ADDENDUM NO. 1

SUBJECT: Solicitation No. X009A

TITLE: Miami-Opa Locka Executive Airport (OPF) Runway 09L-27R Rehabilitation

N107

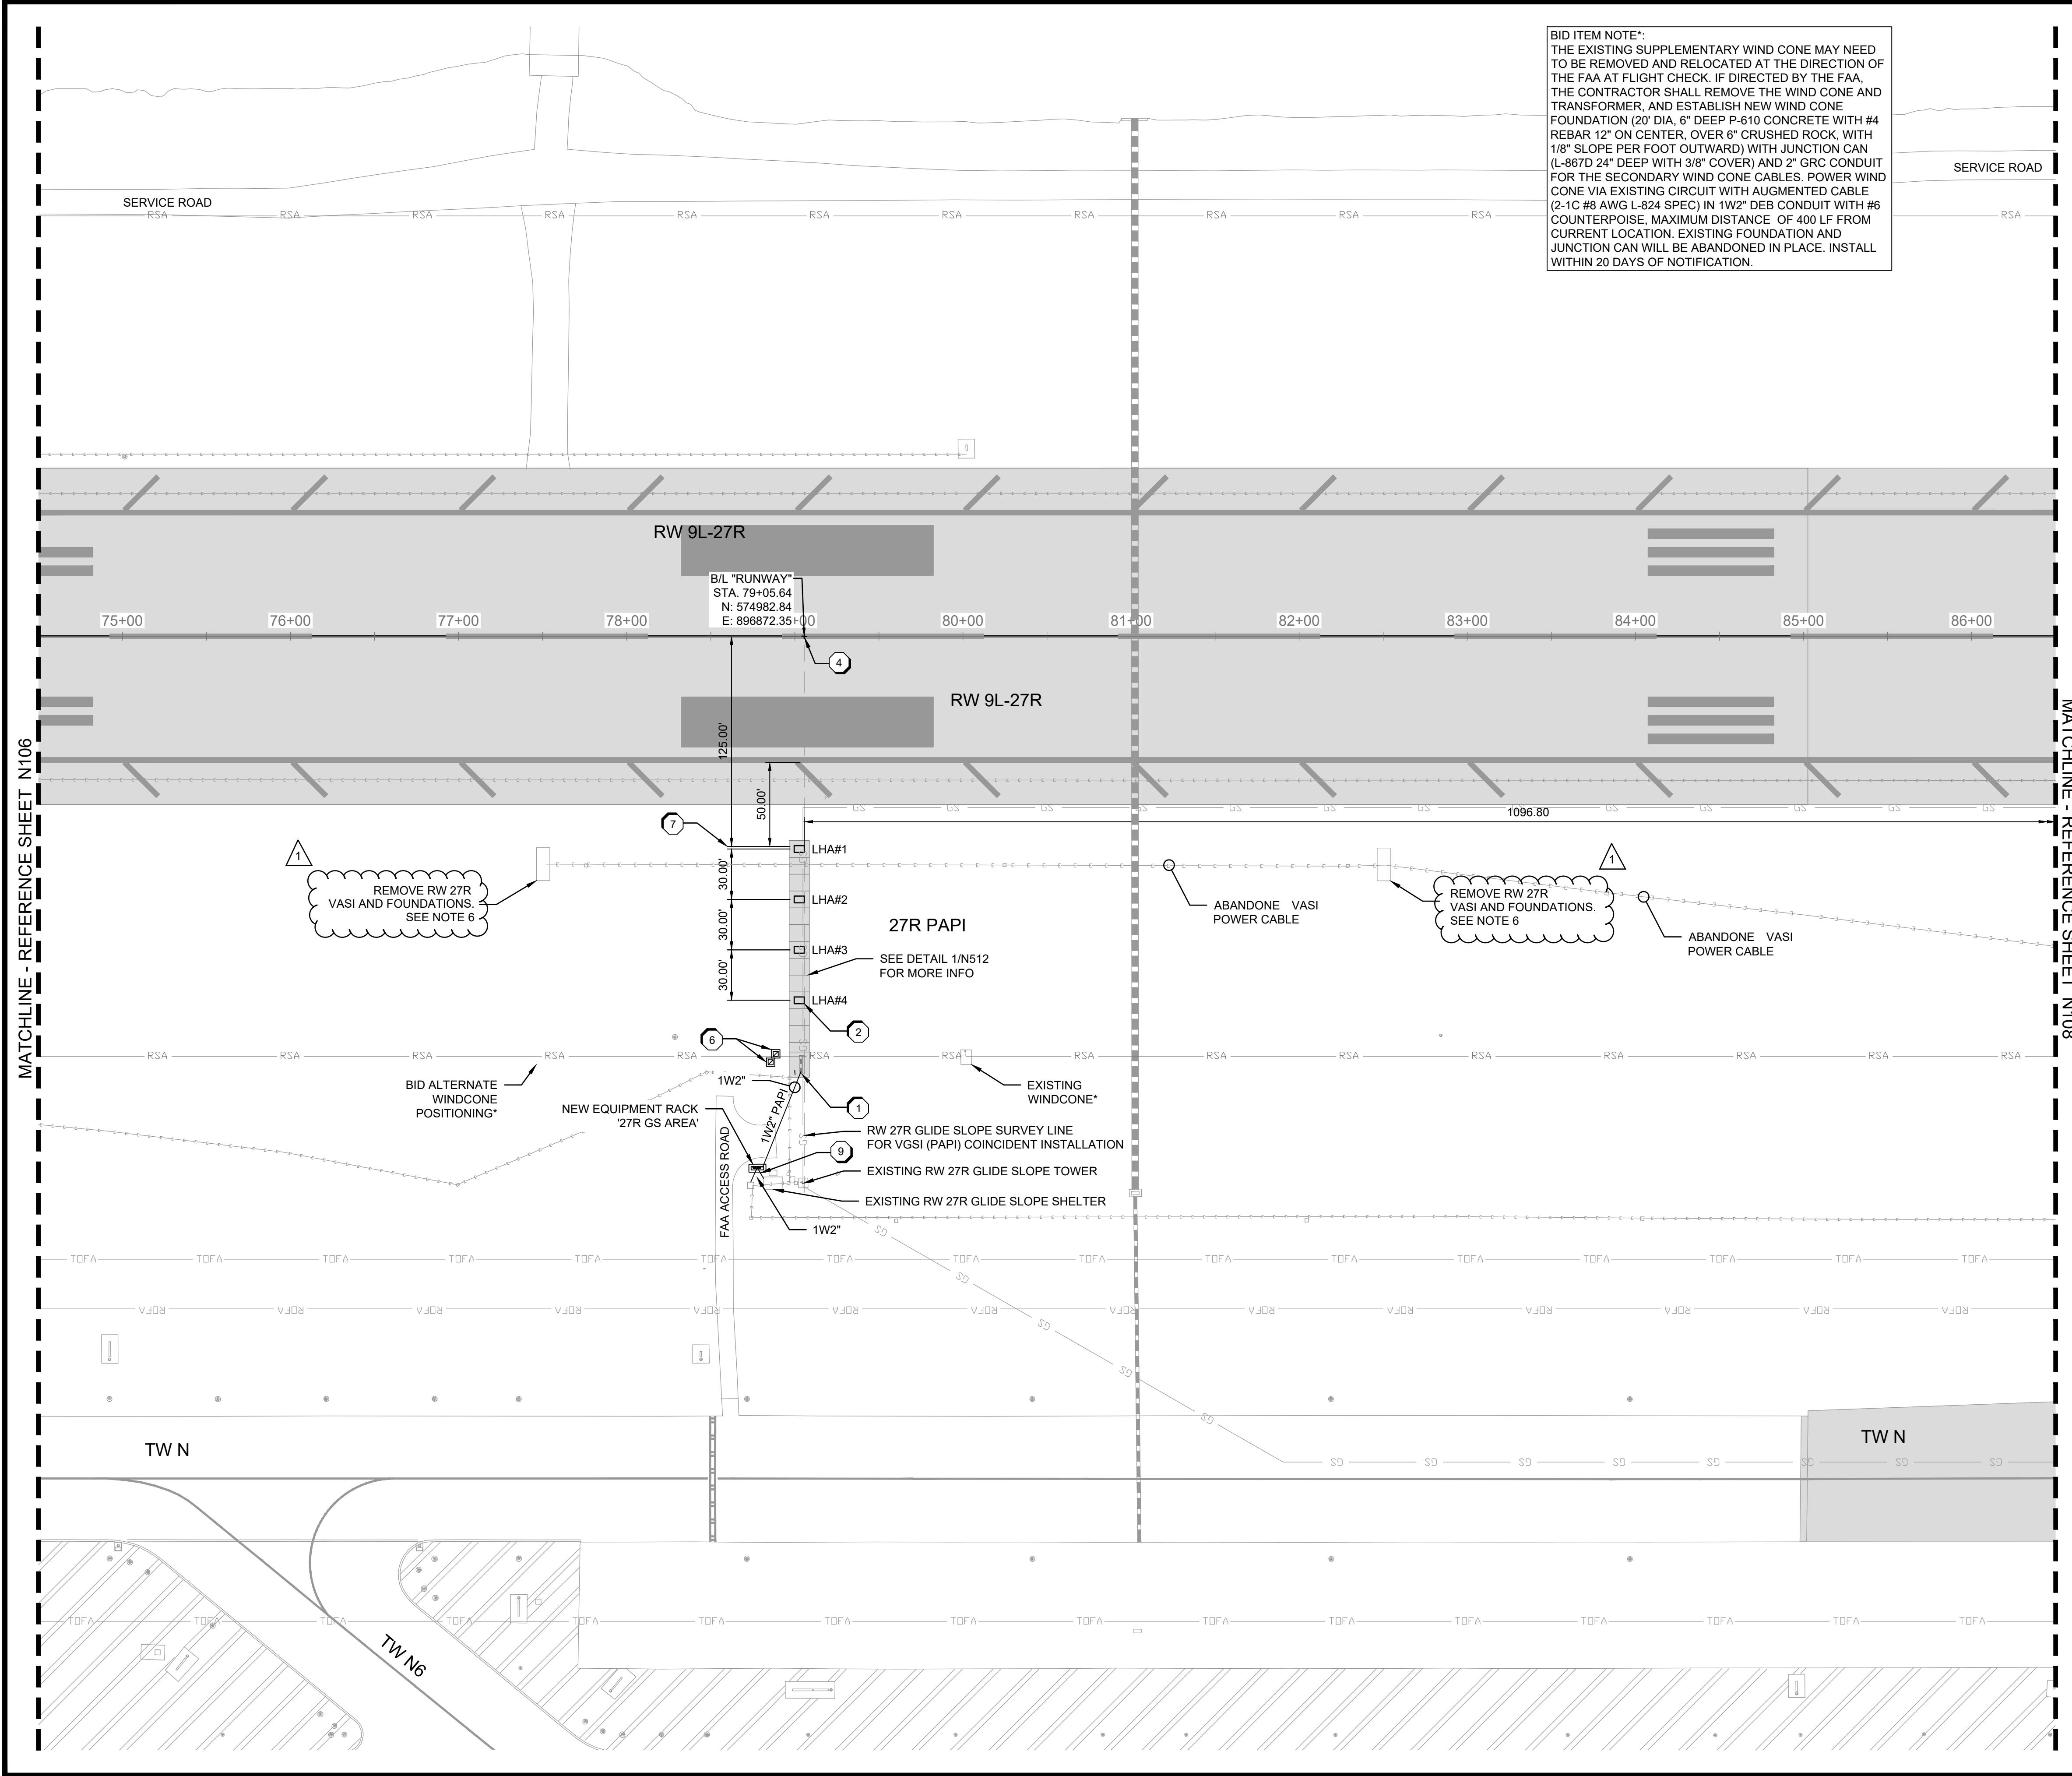
- Question No. 44 DWG N107 – Bid Alternate Windcone Positioning – Please clarify:
- a. Under which bid item this work is going to be paid.
 b. Is a new windcone required? If yes, please provide specifications.

- Question No. 45 DWG N107 – Please clarify if the existing RW 27R VASI foundations are abandoned in place or removed. If removed, please provide details showing its size (LxWxD).

- Answer No. 44 a. To be paid under Bid item No. 66, L-127-5.8 MALS 27R Rebuild
 Recommissioning – Wind cone.
 b. The existing wind cone to be relocated by the contractor. Refer to Attachment 4 of Addendum No. 1:” Construction Plans & Drawings REVISION (Sheet N107)”.

Answer No. 75 Bid Item Note on Sheet N107 details the reuse of existing wind cone at new location and scope of work. Refer to Attachment 4 of Addendum No. 1, Construction Plans & Drawings – Revised, Sheet ED-10

1 TYPICAL MALS THRESHOLD PLAN
N501 SCALE: N.T.S.

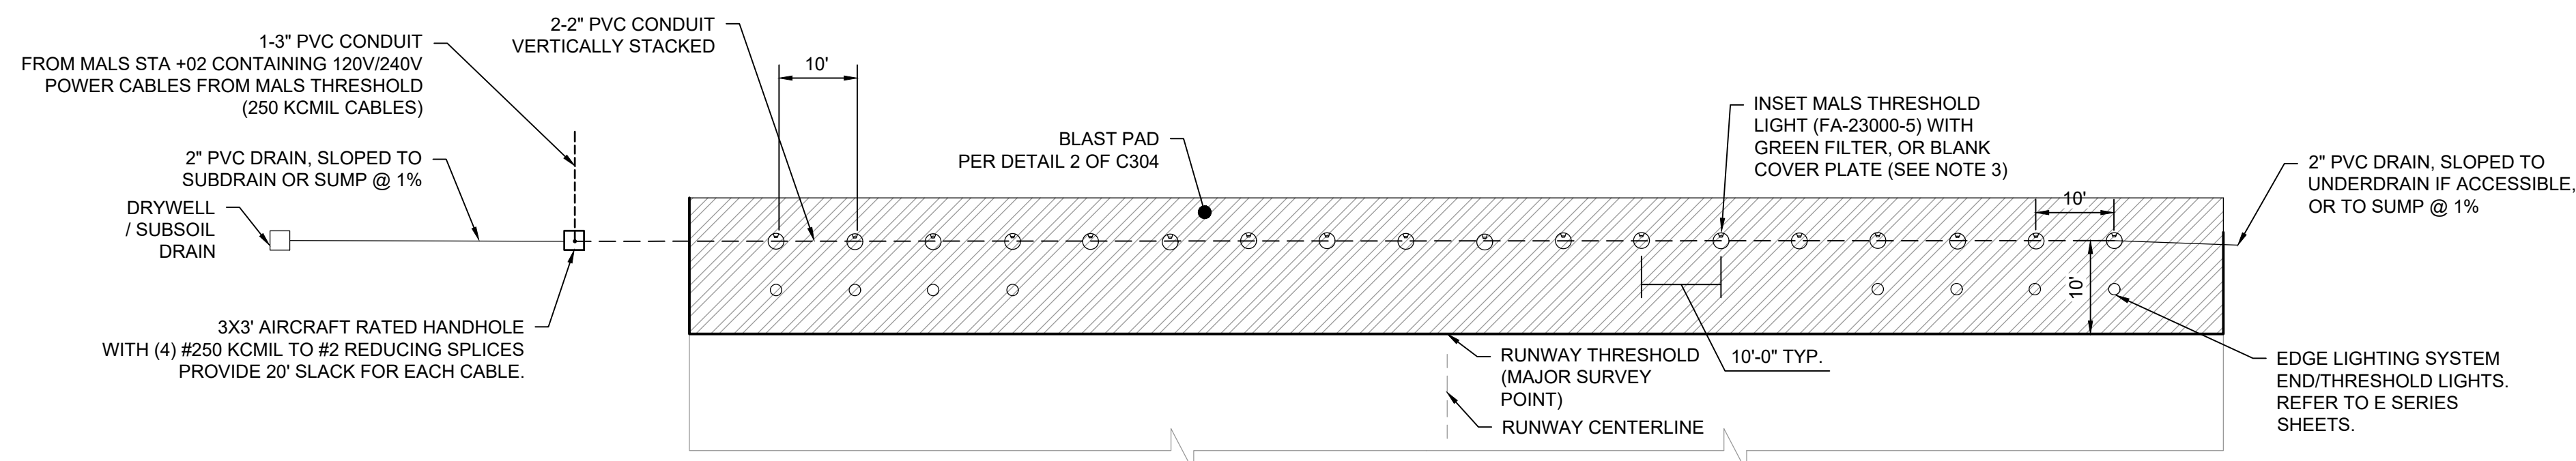
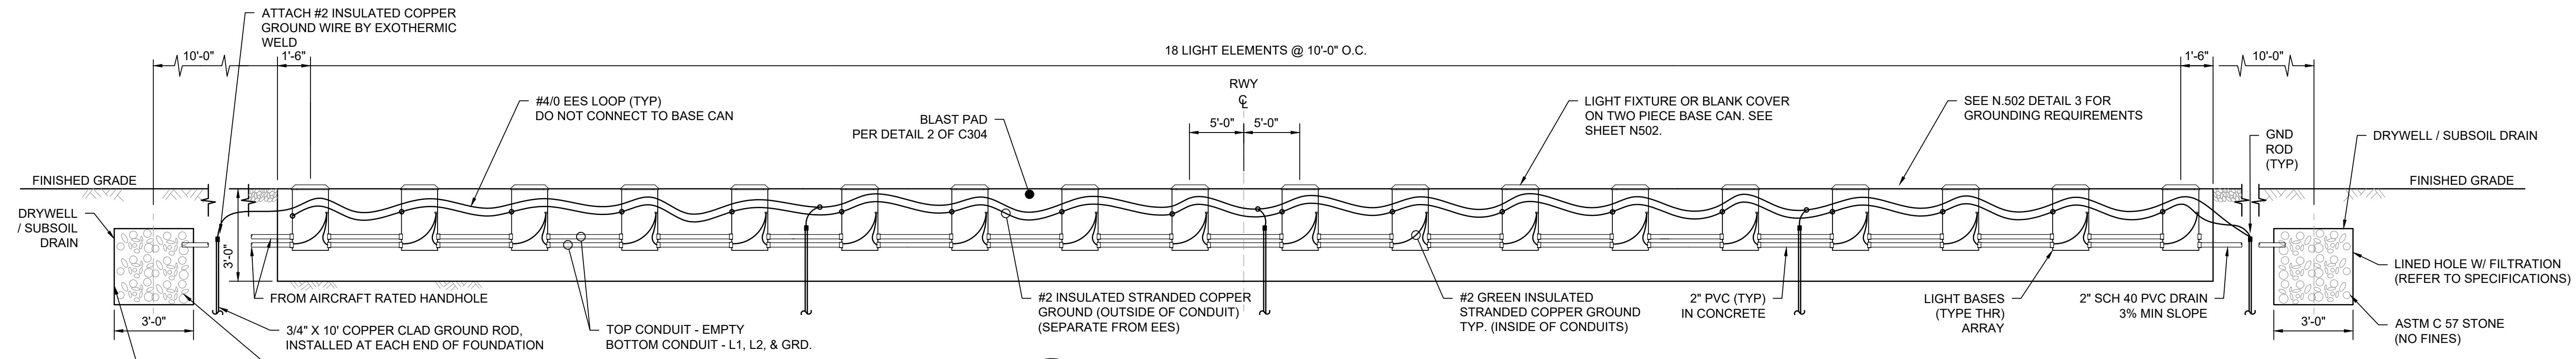
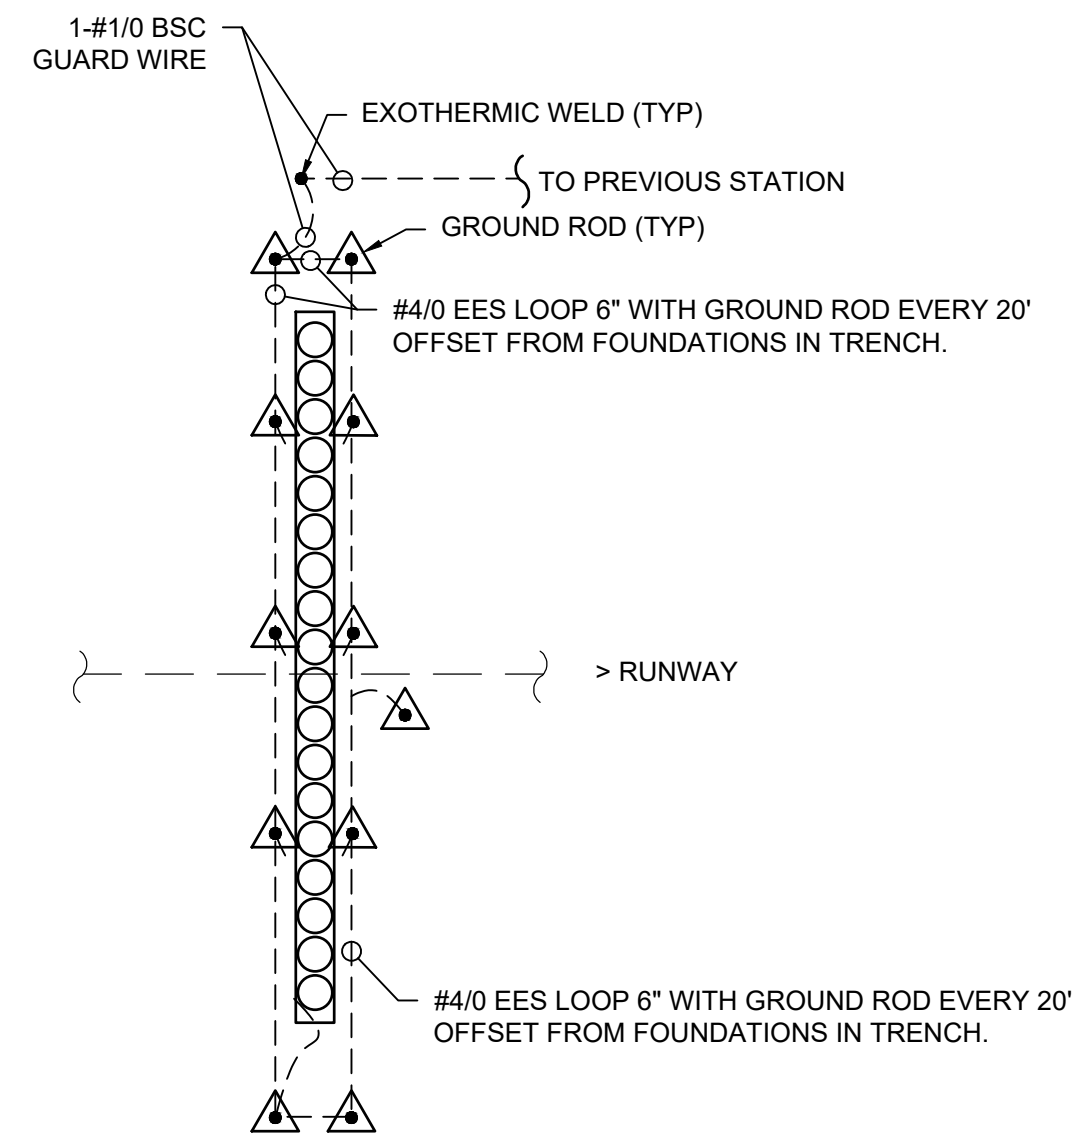
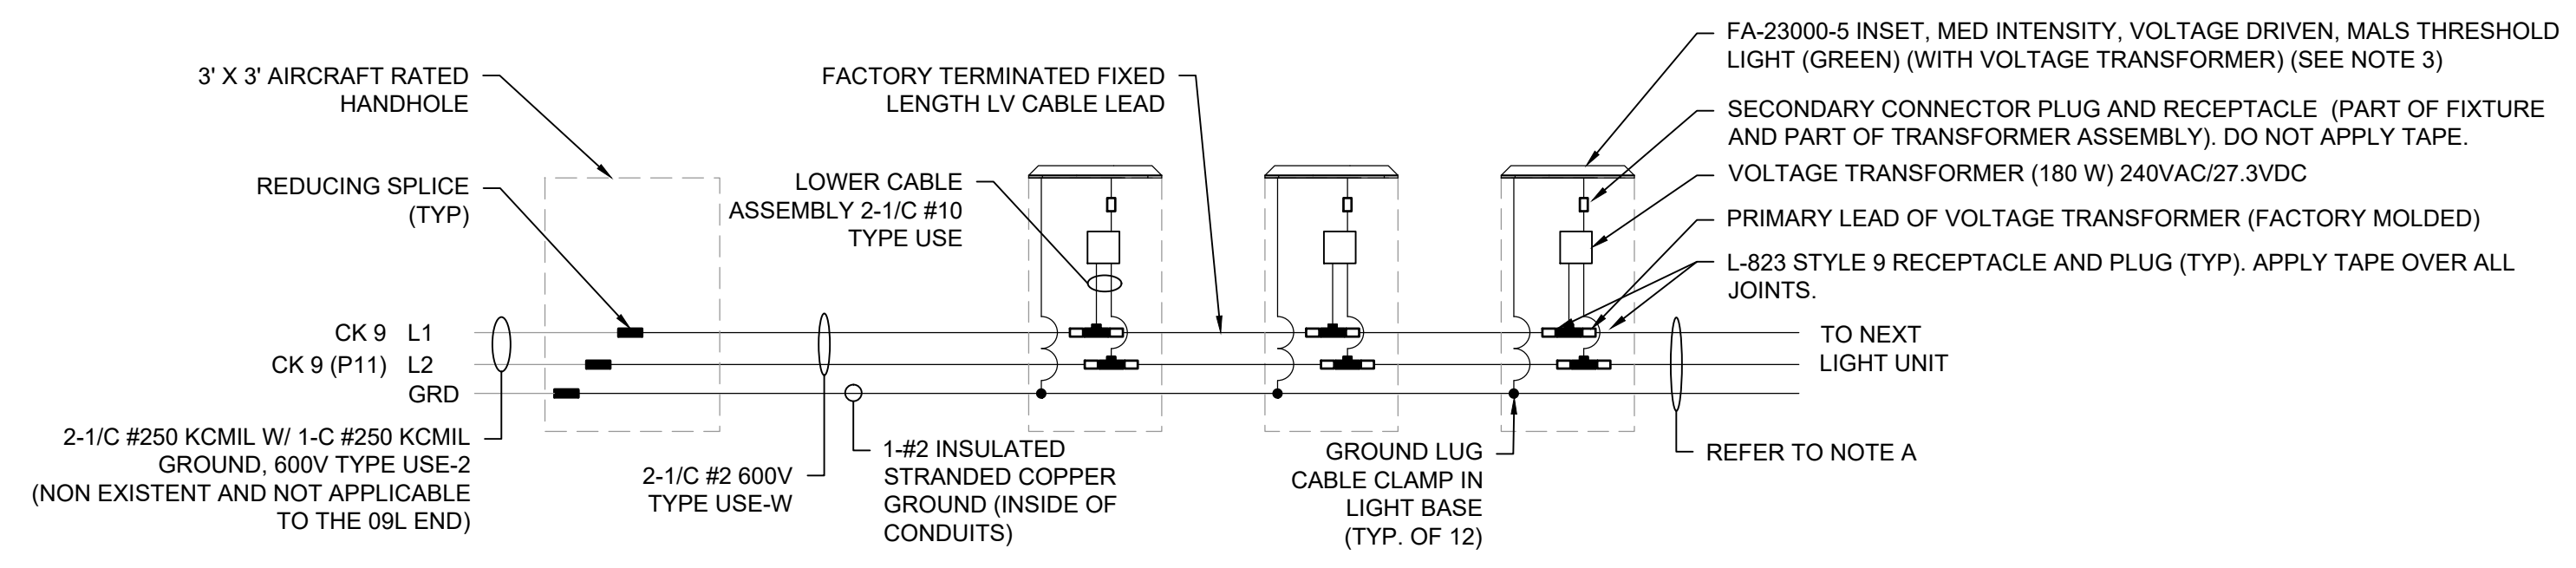
Question No. 49 Specification L-127, DWG N501 and DWG N503 – Specification L-127-3.4 calls for underground cable to be XHHW-2 insulation. However, details on drawings N501 and N503 calls for USE-2 insulation. Please clarify if XHHW-2 insulation is acceptable in lieu of USE-2 insulation.

Answer No. 49 XHHW-2 insulated cables are an allowed alternate to USE-2 in this case. Refer to drawing N501. Refer to Attachment 4 of Addendum No. 1 – Construction Plans & Drawings REVISED, Sheets N501 & N503.
